Product Change Notification

1. ECR #: 159450
Notification #: 308

3. Series:
• T1M44 - TERMINAL

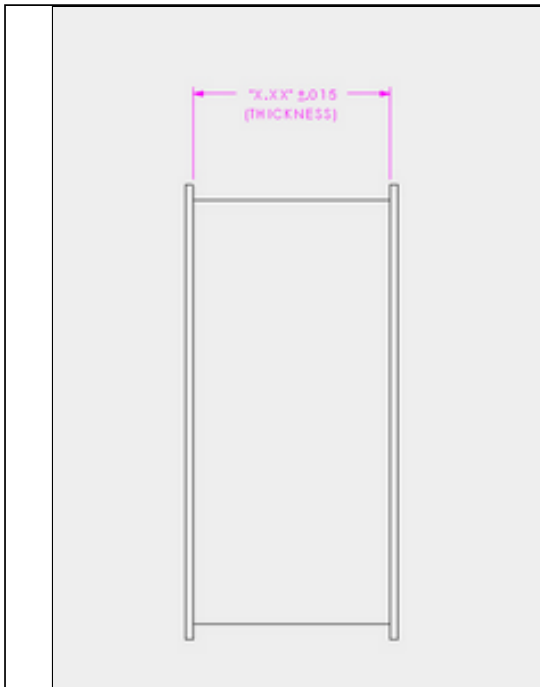
5. Description of Change:
The reel hub thickness will change from 0.75 inch to 1.00 inch

7. Reason for Change:
The reel thickness will be increased to reduce potential for damaging the pins during winding and unwinding.

8. Impact of Change on Form, Fit, or Function:
• Fit - The packaging reel thickness will increase. There will be no change to the component contacts.
